## **Revised Manuscript**

Thank you for the prompt and thorough review of my submitted manuscript, "Linking watershed nutrient loading to estuary water quality with semiparametric models." I really appreciate the substantive and helpful comments from all the reviewers. Line by line comments and responses are included below (reviewer comments are italicized).

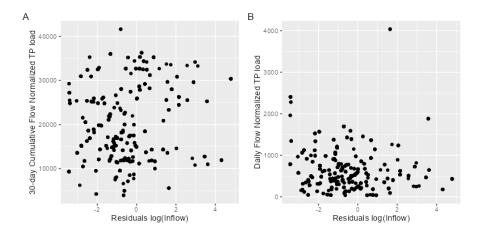
I have some concerns about the methods starting on line 184 that describe how the load estimates are related to the estuarine data. First, I strongly encourage the authors to develop these models using cumulative or lagged estimates for the flow and load variables. It appears that these are currently modeled as the estimates for the same day the water quality parameter was sampled. I would not expect much of a relationship between water quality and the independent variables at that time scale. I suspect that the relationships the author shows regarding flow/load with the response reflects some level of temporal autocorrelation between the daily estimates and preceding conditions/loads, where the latter may be a truly causative relationship. I see two potential approaches to remedy the issue. One, the author could test different lagged values for flow and load, although this would require a bit of trial and error. A potentially better solution is to use the aggregate flow volume and load between the sample dates as a sum of the volume and mass, respectively, between each observation of the time series for the response variable. I would expect these aggregate measurements to be much more strongly correlated to the response variables than the daily values that are currently used. This limitation is noted on lines 371-374, so I'm curious why the authors did not use this approach.

My second concern about the models in eqns. 5-7 also relates to the flow and load variables. It's stated on line 199-201 that flow-adjusted load values were used, which makes sense, but I don't understand how this additional analysis differs from the flow-normalization in the previous section (lines 176 – 179). Why not just use the flow-adjusted loads from the previous models? Once this is clarified (or corrected), it might make more sense to change eqn 6 to include smoothers for ddate, yday, and flow-normalized load, and eqn 7 to included smoothers for ddate, yday, and load. These wouldn't be "nested" models for AIC comparison, but would perhaps provide a better approach to evaluate loads related to natural or non-natural variation. I don't see the value in including flow as a separate variable since it's basically a surrogate for total load.

**Response:** I am combining my response to both these comments since they are related. These are valid concerns and related to a comment made by Reviewer 3 (probably indicative that I better make a change here).

- (1) I agree that it makes more sense to utilize the flow normalized loading estimates generated in the previous section. The methodology and results have been adjusted to correct this.

- (2) I struggled with the concept of incorporating lag effects while developing these models, it didn't occur to me to utilize aggregated loads. I think this is a good approach and will incorporate it into the models. However, since the estuary water quality data is not measured at equal intervals, I believe the suggested aggregation method is potentially inappropriate. For example, if a quarterly measurement was missed you can end up aggregating 6 months of loads for a given data point instead of 3 months. Walker et al. (2021) found that after Hurricane Harvey (a massive magnitude storm) water quality impacts in Lavaca Bay and adjacent estuaries were restricted to a relatively short period, somewhere between 20 days and a few months. Based on this info, I am incorporating a 1-day lagged, 30-day cumulative load.

- (3) I want to emphasize that the flow term used in equation 7 are the residuals from the seasonal inflow model. Although loads and flows are tightly correlated, the use of the residuals from the flow ~ s(doy) model and aggregated flow normalized loads (noted above) helps separate the influence of human influenced loads from the influence of higher than normal streamflows on estuary water quality. The figure below shows the lack of apparent covariance between inflow residuals and cumulative TP loads.
